Comments on Proposed ECO-SPA & Resort in Dingli EIA and AA 9th January 2019

Figure 1. Scopolis shearwater distribution in the Maltese Islands (Sultana et al. 2011)

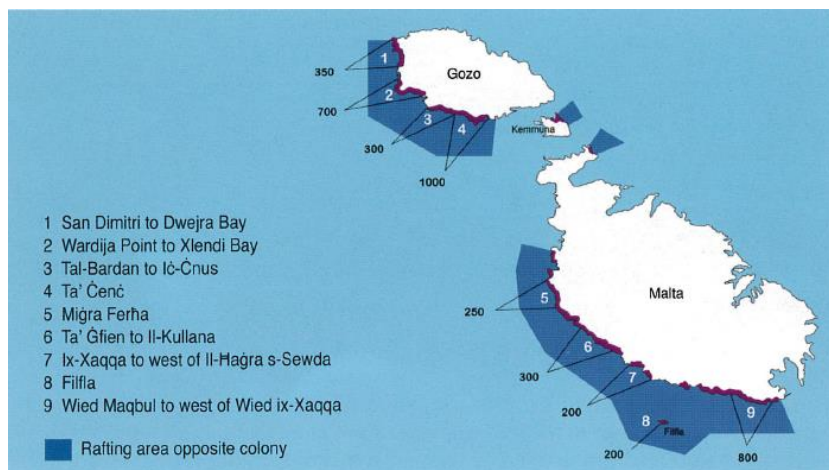
Furthermore, appendix X Avifauna does not mention the approximate distance of the proposed development to important nesting sites of Scopoli's Shearwater along Dingli Cliffs and disregards potential disturbance that this development might cause for these birds in terms of light and noise pollution. In fact, the EIA is not looking into potential impacts on the species at all and therefore an inclusion the specifically protect the species is completely lacking. Mitigation measures of impacts from light pollution during the construction phase was disregarded in the EIA. Should the proposed development be further considered, it is important to not carry out construction works that cause major light, noise and vibration disturbance during the months of September to December (fledging period of Scopoli's Shearwater along Dingli Cliffs).
